PURPOSE
It has been reported in the field that the Quick pin can fail in such a way as to become stuck in the Mod connection. The failure is the internal compression spring slips past locking lever causing the locking lever to jam in the locked position.

703712/A

Spider®

710029-1 Quick Pin	702181-1 Pin;Hitch 75x2.5 W/Lanyard and Clip

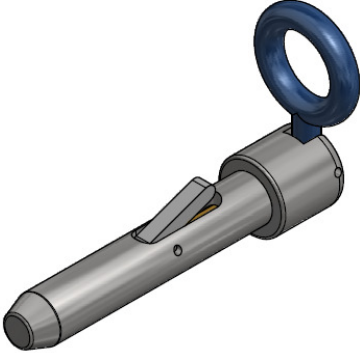
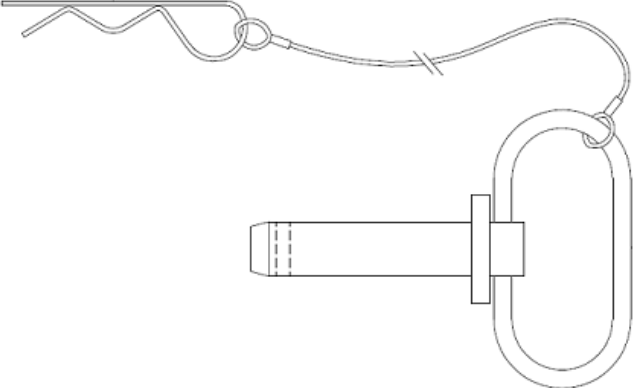
Spring slips off of locking lever 710029-1 |

| A new pin pn 702181-1 with a lanyard and clip attached is available to replace pn 710029-1 quick pin.

If you have a PN: 710029-1Quick pin that has a failure and is covered within warranty, contact either Customer Service or Product Support for RMA to return quick pins to TOC and arrange replacement pin PN; 702181-1 Pin with Lanyard and Clip.
